Letter Number 2.18.045
EP-AD-601, Emergency Action Level Technical Bases Document, Revision 9 and
associated 10 CFR 50.54(q) Review

PNPS EMERGENCY PLAN ADMINISTRATIVE PROCEDURES	NON-QUALITY RELATED PROCEDURE	EP-AD-601	Revision 9
	REFERENCE USE	Page 1 of 351	
Emergency Action Level Technical Bases Document

Change Statement

Figure H-1 Screenhouse Bay Water Levels

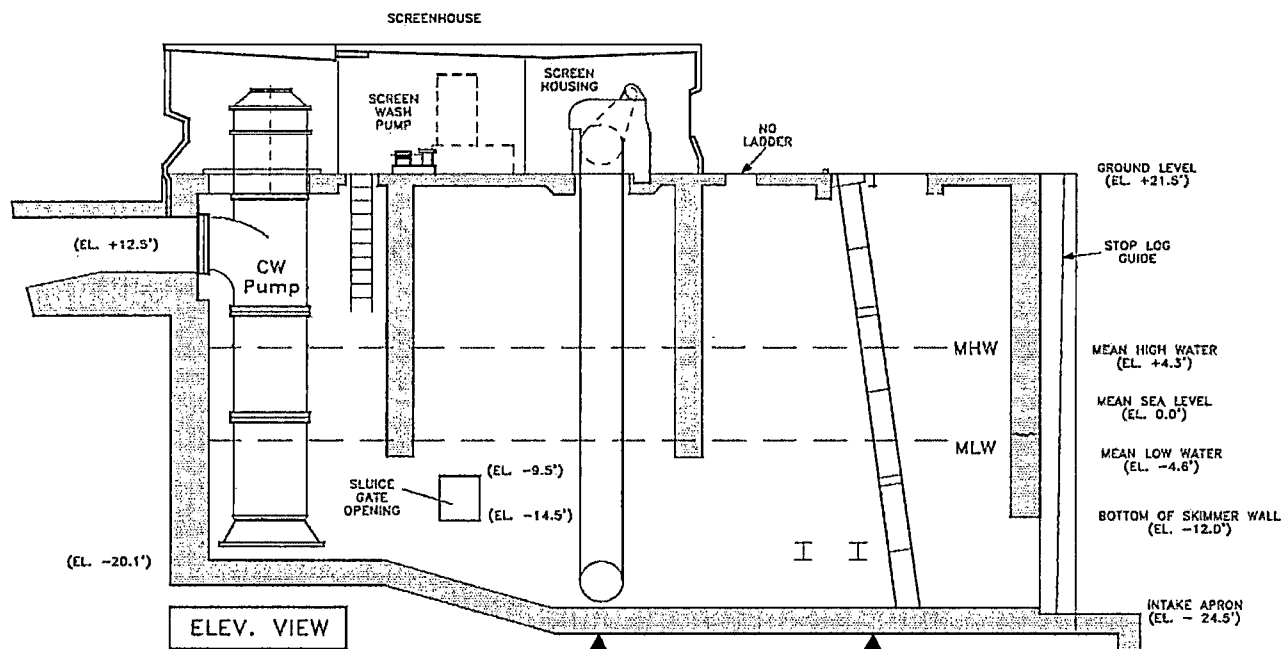
- 1) Attachment 9.2, Sheet 11 of 70, Unusual Event – HU1.5, PNPS Basis:

"As illustrated in Figure H-1 (ref. 1, 2), ground level at the screenhouse is +21'6" MSL and well below the flood level of +13'6" MSL."

- 1) This change to the EAL Technical Bases Document corrects an inadvertent and inappropriate use of the term "below" versus "above" when referencing comparative water heights within Figure H-1, "Screenhouse Bay Water Levels". Figure H-1 is included as a visual aid within PNPS EALs HA1.6 and HU1.5 and provides a cross-cutting view of bay water levels applied to screenhouse elevations. This figure clearly depicts a ground level of the screenhouse at +21'6" MSL (Mean Sea Level) accompanied with a comparison reference to the Flood Level of +13'6" MSL (Mean Sea Level). It is apparent through this discussion that +21'6" (above) MSL would be well above, not below, a flood level of +13'6" (above) MSL. The change to this procedure corrects the use of the word "below" by replacing this word with "above".
Further, in this same PNPS Basis discussion, application of description of elevations using the term "well above" is used correctly when referencing the bay flood level of +16'0" of the Maximum Monitored Water Level (HA1.6) and +13'6" Flood Level (HU1.5).

- 2) The term "(+21.5') from Figure H-1 was added parenthetically to the PNPS Basis discussion to enhance recognition of equivalency with the existing term "+21'6" which is used within the proximate tables and discussion.

As illustrated in Figure H-1 (ref. 1, 2), ground level at the screenhouse is +21'6" (+21.5') MSL and well above the flood level of +13'6" MSL. Since the entrances to all structures containing equipment necessary for reactor shutdown and cooling are at elevations well above +13'6" MSL, they are protected against flooding from external sources. Seawater bay water level < -13'9" MSL is the design minimum level for the SSW pumps.

"As illustrated in Figure H-1 (ref. 1, 2), ground level at the screenhouse is +21'6" (+21.5') MSL and well above the flood level of +13'6" MSL."

Figure H-1 Screenhouse Bay Water Levels

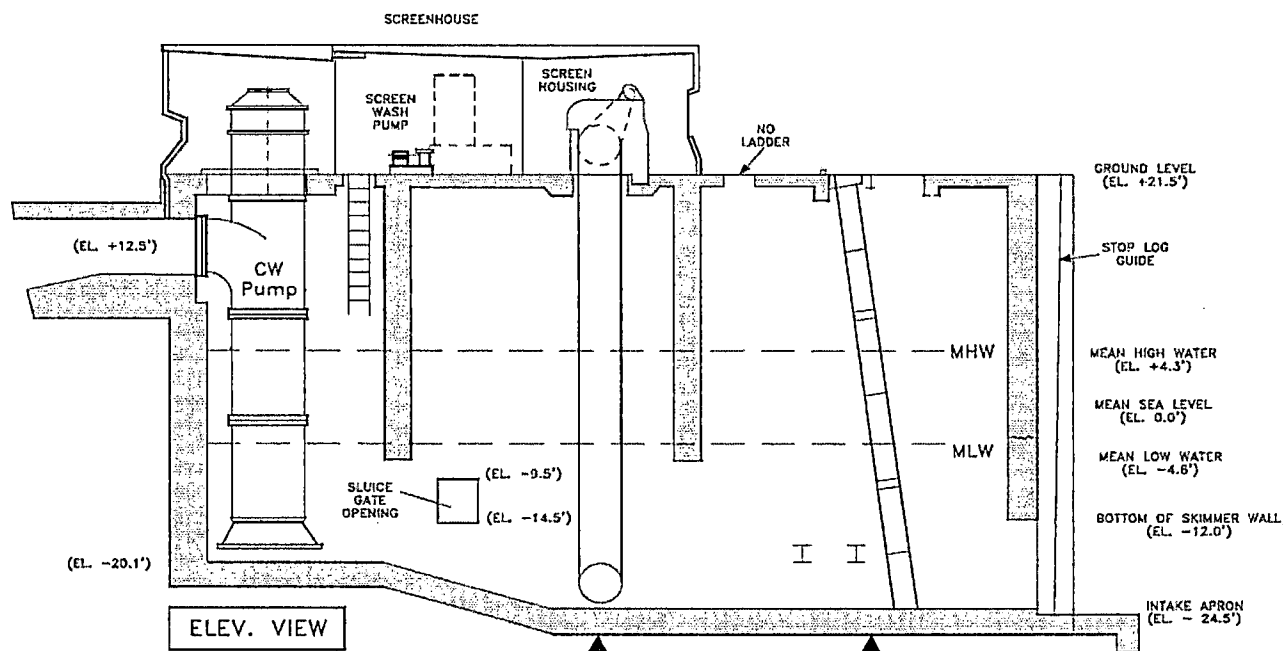
- 2) Attachment 9.2, Sheet 29 of 70, Alert – HA1.6, PNPS Basis:

"As illustrated in Figure H-1 (ref. 1, 2), ground level at the screenhouse is +21'6" MSL and well below the flood level of +13'6" MSL."

As illustrated in Figure H-1 (ref. 1, 2), ground level at the screenhouse is +21'6" (+21.5') MSL and well above the flood level of +13'6" MSL. Since the entrances to all structures containing equipment necessary for reactor shutdown and cooling are at elevations well above +16'0" MSL, they are protected against flooding from external sources. The specified water levels are the maximum and minimum monitored seawater bay water levels.

"As illustrated in Figure H-1 (ref. 1, 2), ground level at the screenhouse is +21'6" (+21.5') MSL and well above the flood level of +13'6" MSL."
